Access Compliance Report

Public Rights-of-Way

(Curb Ramps)

Intersection ID: 7190	Main Street: EQUIPMENT_DR	Cross Street: N_GRAHAM_ST	Location: S
ADA ID: B0D729E30B04	Ramp Type: Perp	Initial Pass/Fail: Fail	Overall Compliance: No
Severity Score: 8.75			
Codes/Mitigation Info/Possible Solution		Field Measurements/Component Compliance

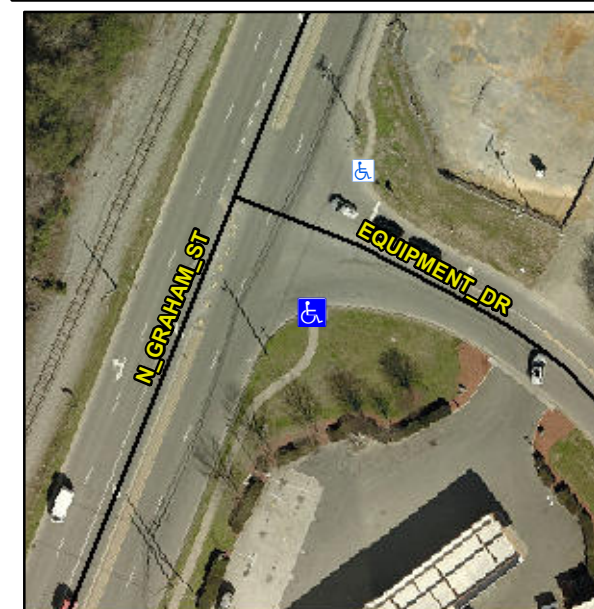
Not Found, R304.5.1

Compliance	Description	Data	Compliance	Description	Data
N/A	Ramp Length (in)	64.0	Yes	Ramp Slope (%)	7.3
No	Ramp Width (in)	43.0	Yes	Ramp XSlope (%)	0.1
N/A	Flare Type LT	N/A	N/A	Flare Type RT	N/A
N/A	Flare Slope LT (%)	N/A	N/A	Flare Slope RT (%)	N/A
N/A	Flare Traversable LT?	N/A	N/A	Flare Traversable RT?	N/A
N/A	Landing Length (in)	N/A	N/A	DWS Provided?	N/A
N/A	Landing Width (in)	N/A	N/A	DWS Contrast?	N/A
N/A	Landing Slope (%)	N/A	N/A	DWS Length (in)	N/A
N/A	Landing X Slope (%)	N/A	N/A	DWS Full Width?	N/A
N/A	Landing Curb? (Y/N)	N/A	N/A	DWS Offset (in)	N/A
N/A	Shared Landing?	N/A			
N/A	Gutter Ponding?	N/A	N/A	Gutter Slope (%)	N/A
N/A	Gutter Lip Ht (in)	N/A	N/A	Gutter X Slope (%)	N/A
N/A	Painted X Walk1?	No	N/A	Painted X Walk2?	N/A
	X Walk 1 Direction	To NE		X Walk 2 Direction	N/A
N/A	X Walk 1 Width (in)	N/A	N/A	X Walk 2 Width (in)	N/A
	X Walk 1 Slope (%)	2.3		X Walk 2 Slope (%)	N/A
	X Walk 1 X Slope (%)	0.4		X Walk 2 X Slope (%)	N/A

Remove & Replace Entire Ramp.
